# RICHMOND 300 ZONING CODE REFRESH

Review of Changes Made For November Draft  
December 2025 ZAC Meeting

# SUMMARY OF NOVEMBER DRAFT CHANGES

# RESIDENTIAL BUILDING COVERAGE

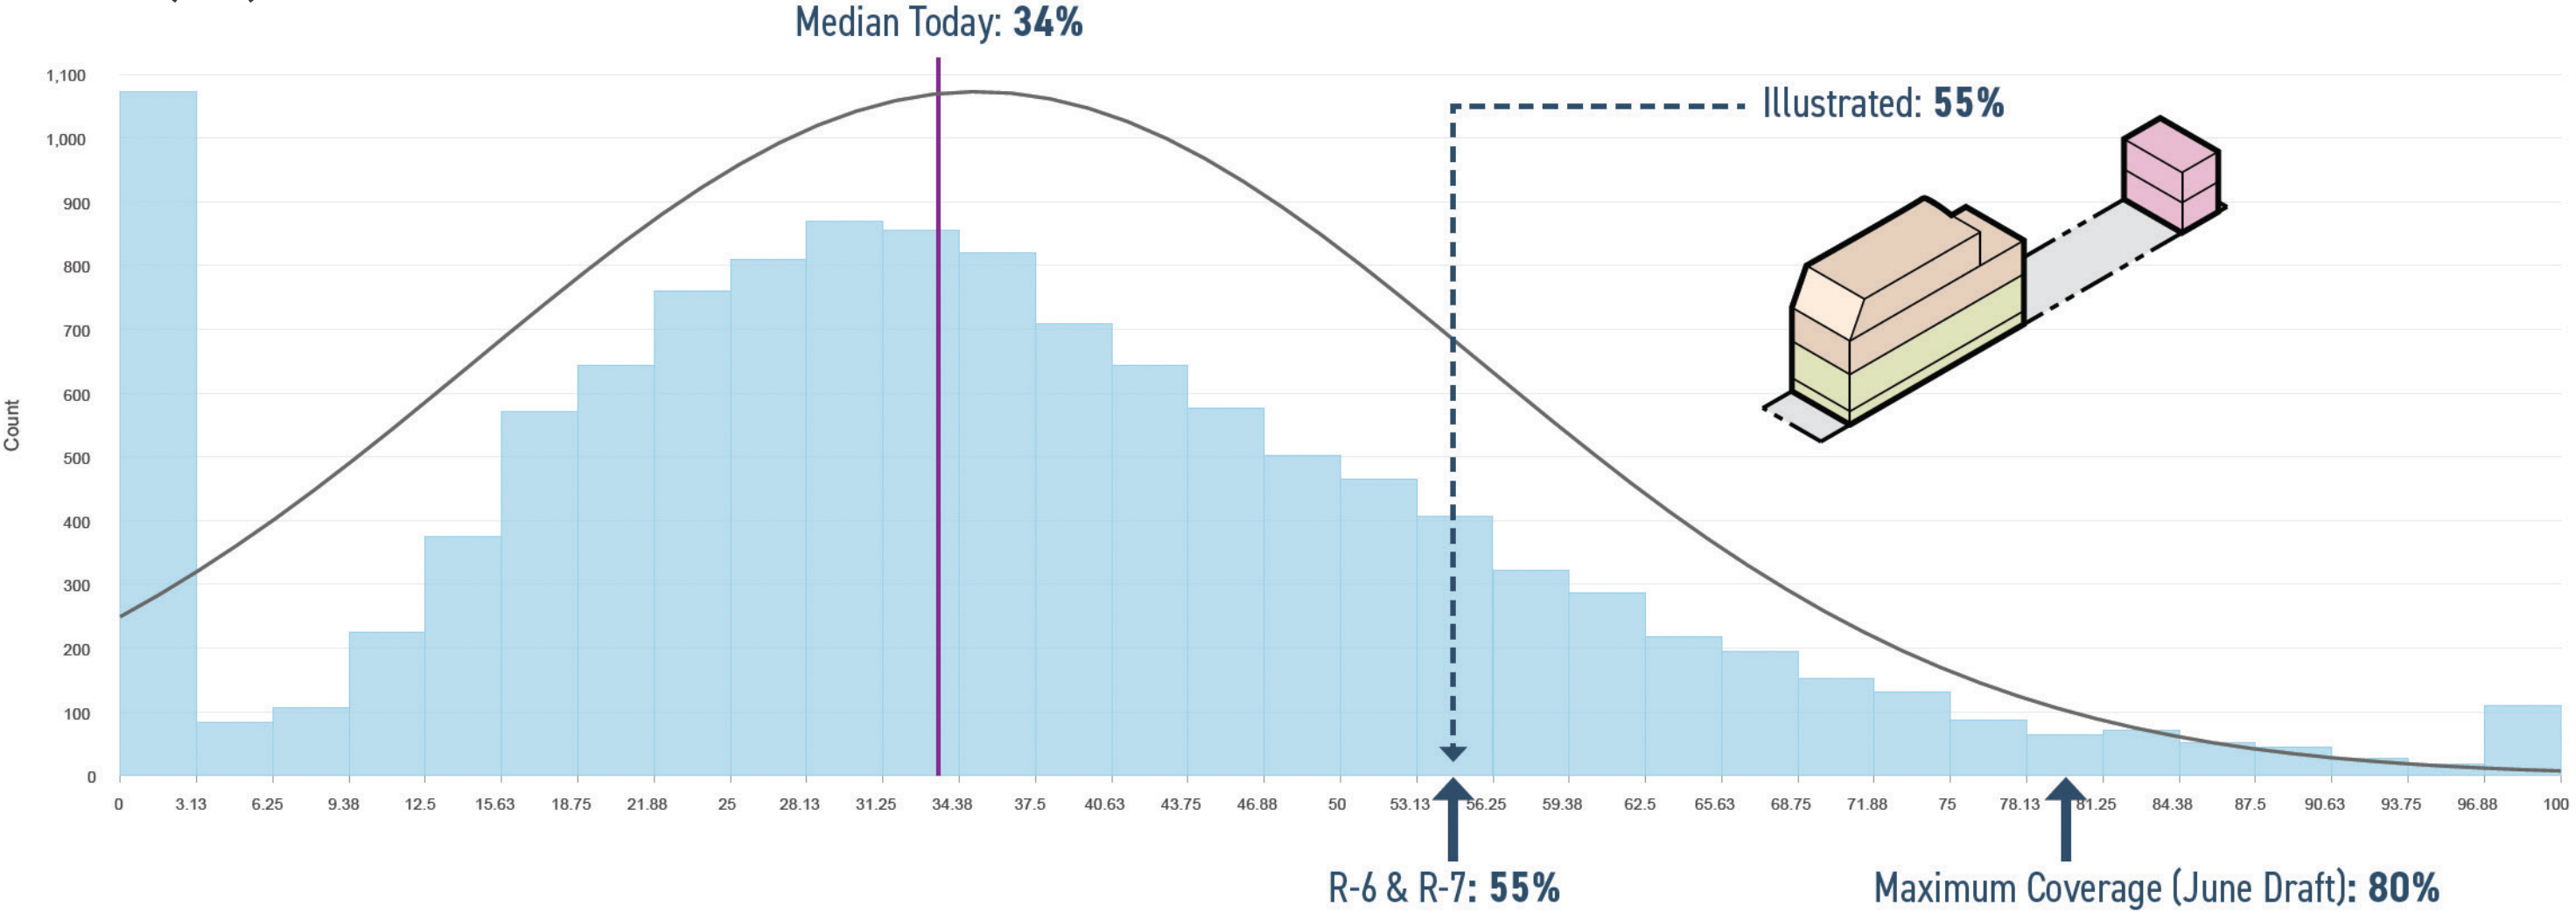
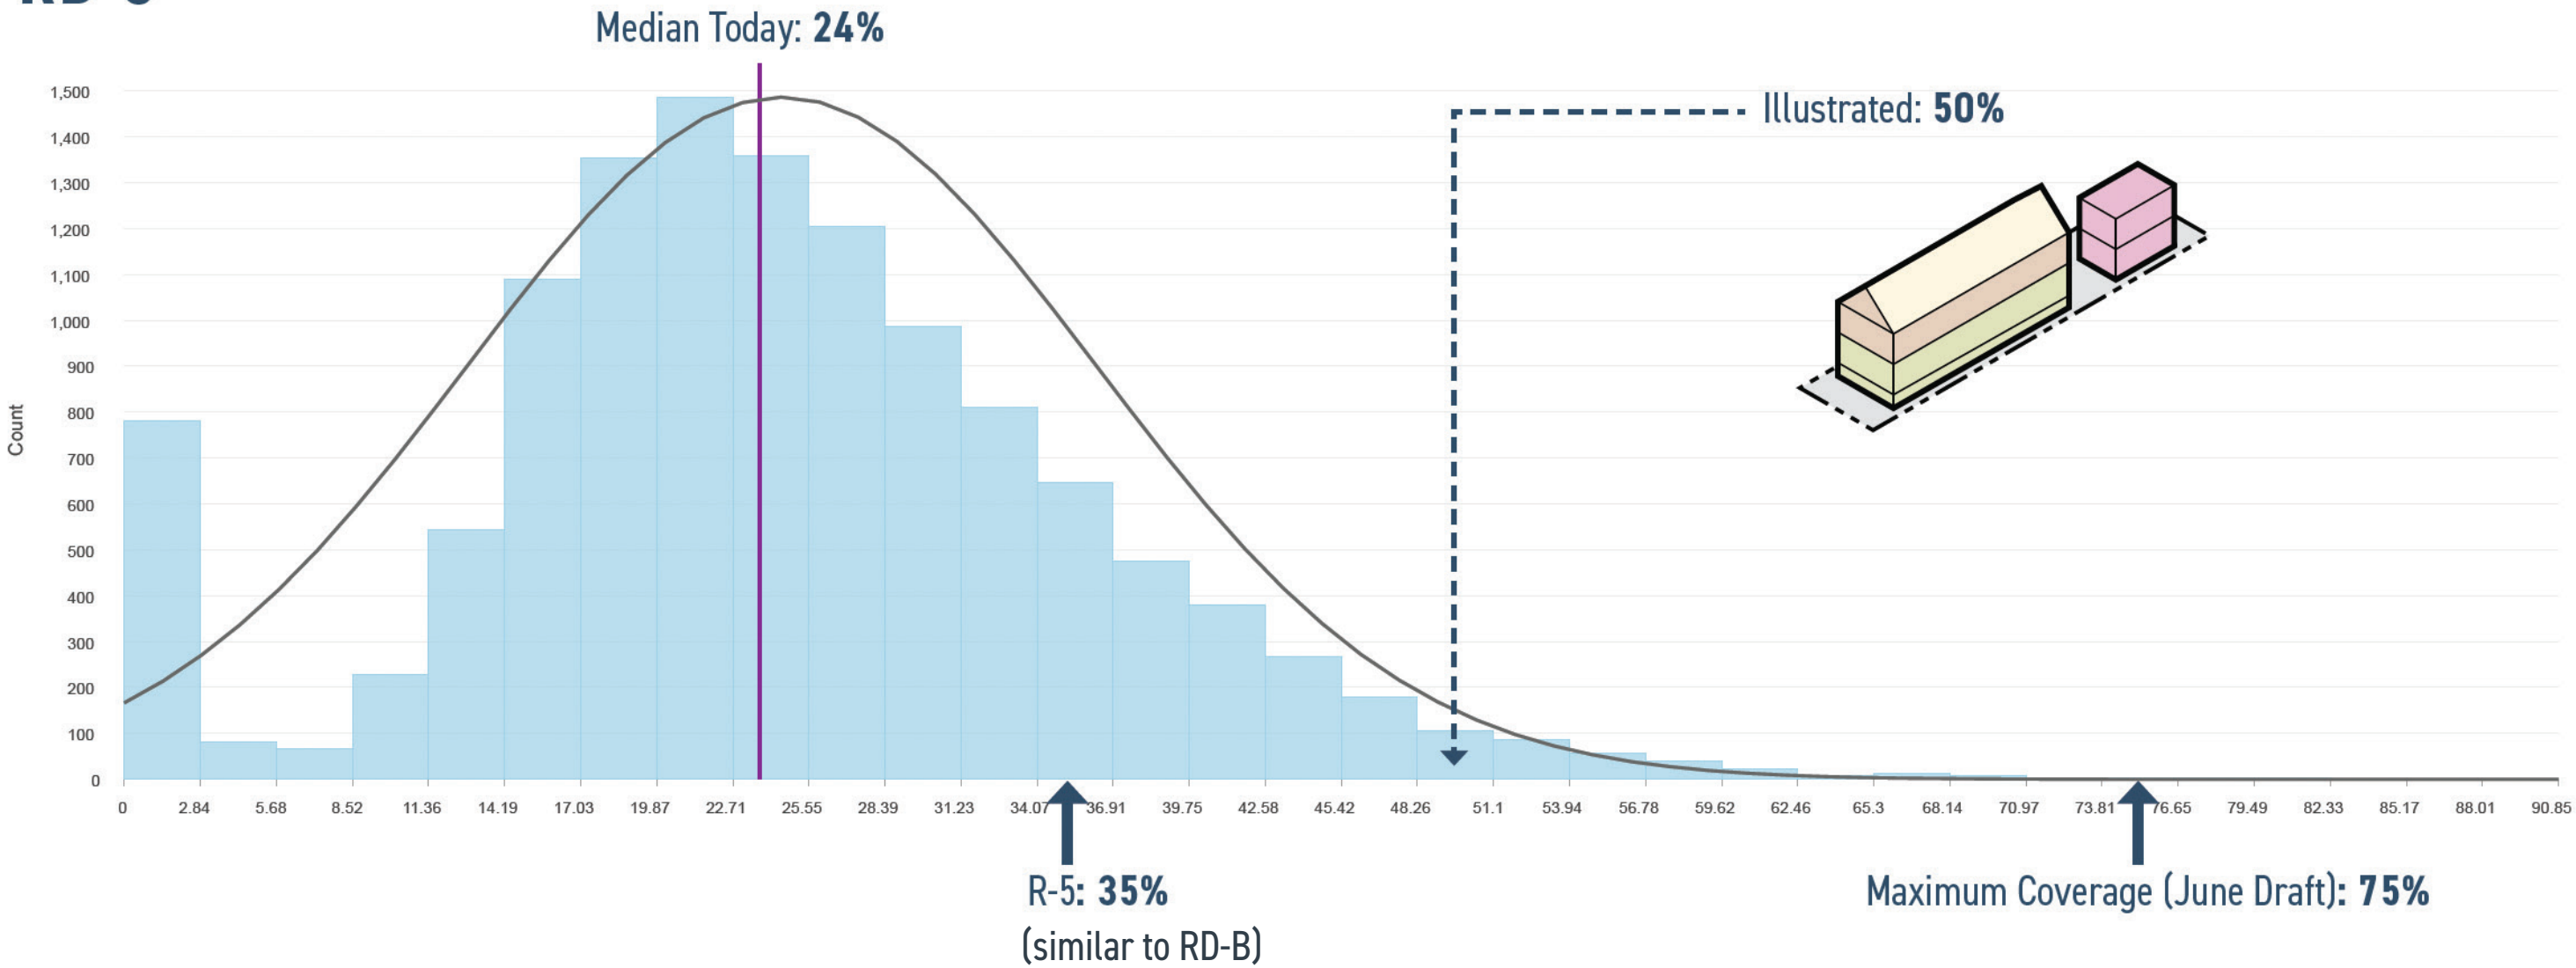
- + While some appreciated that higher building coverage percentages would support infill housing, others expressed concern about loss of open space

- + Maximum building coverage has been lowered to percentages closer to the current Zoning Code

November Draft: 60%

November Draft: 50%

# SIDE AND REAR SETBACKS

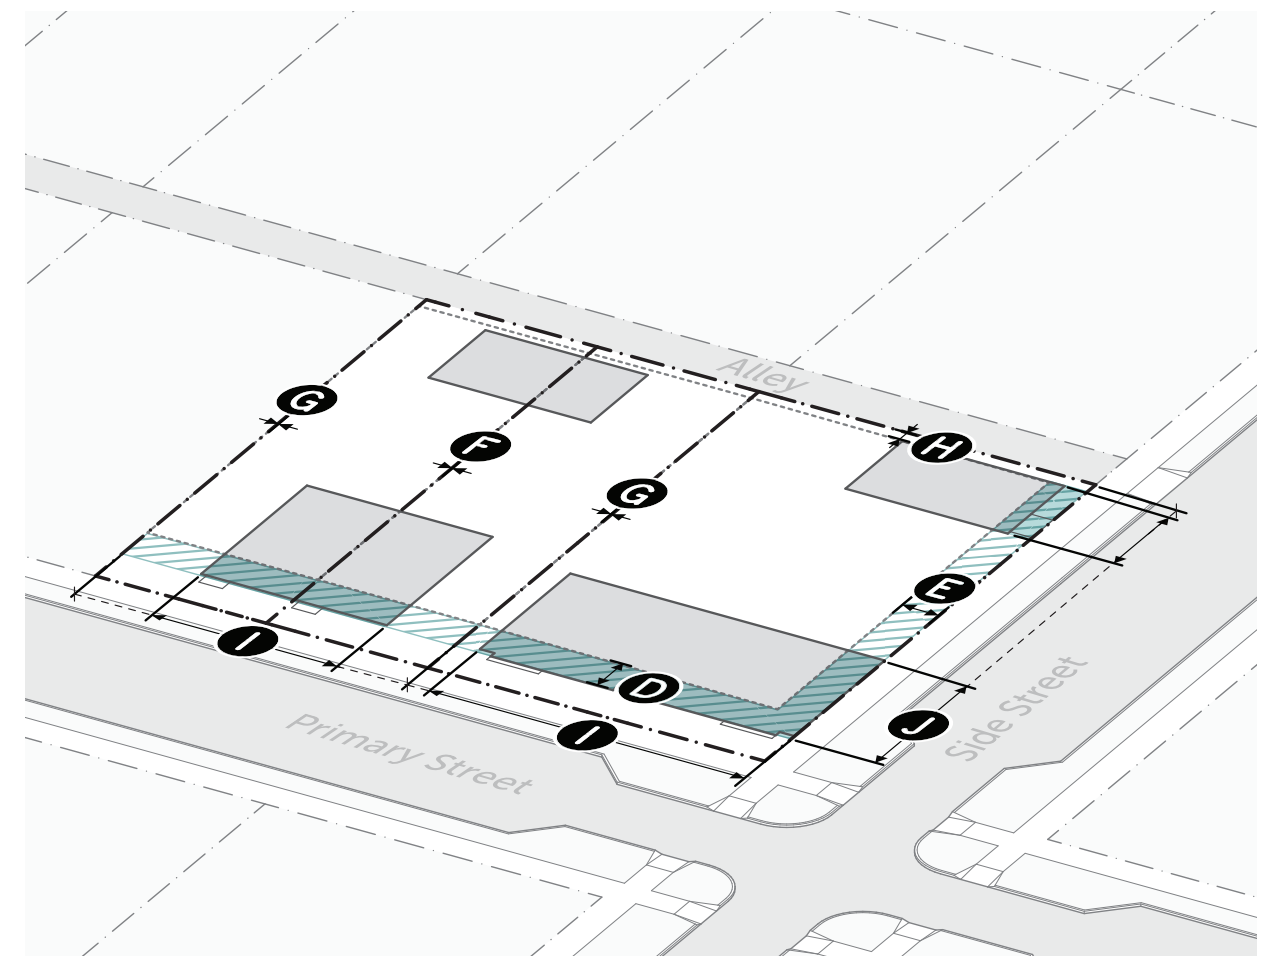
- + Attached buildings by definition have no side setbacks, but concerns were raised about detached structures having no side setbacks in RA- districts

- + Side setbacks have been added to RA, RM-A, and RM-B
- + Side setbacks do not apply on internal lot lines when a block of attached buildings (rowhouse) are constructed together

# HEIGHT LIMITS

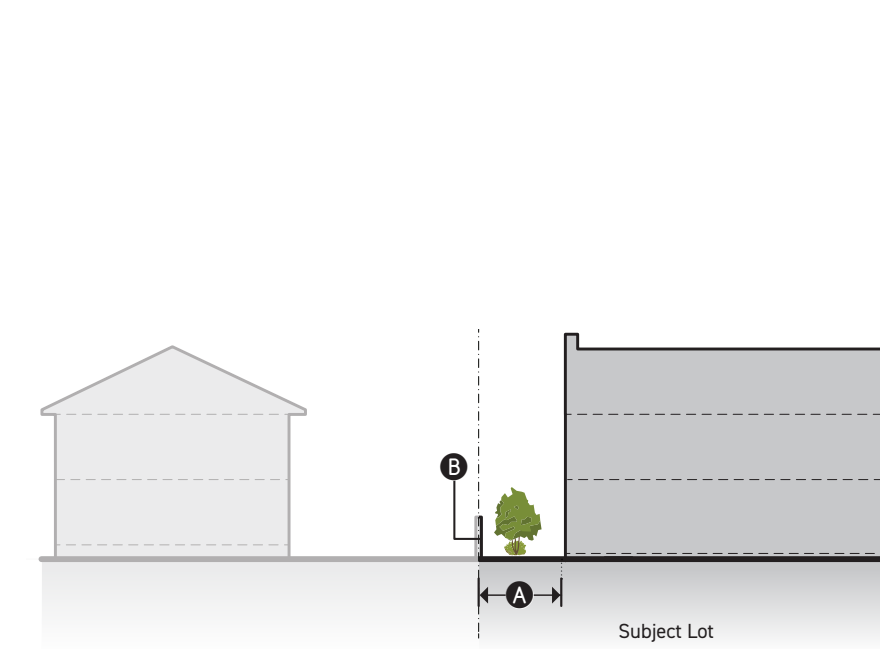
- + There were concerns about more intensive and less intensive zoning districts abutting each other
- + Some had privacy concerns and were worried about solar access
- + Some suggested that areas in the City could handle taller buildings (like Scott's Addition)

- + Transition standards now apply to more districts and the metrics have been refined
- + Some MX- blocks have been remapped where lot depth would constrain building height (for example, MX-13 has been remapped to MX-7 or MX-5 in some cases depending on the lot depth)
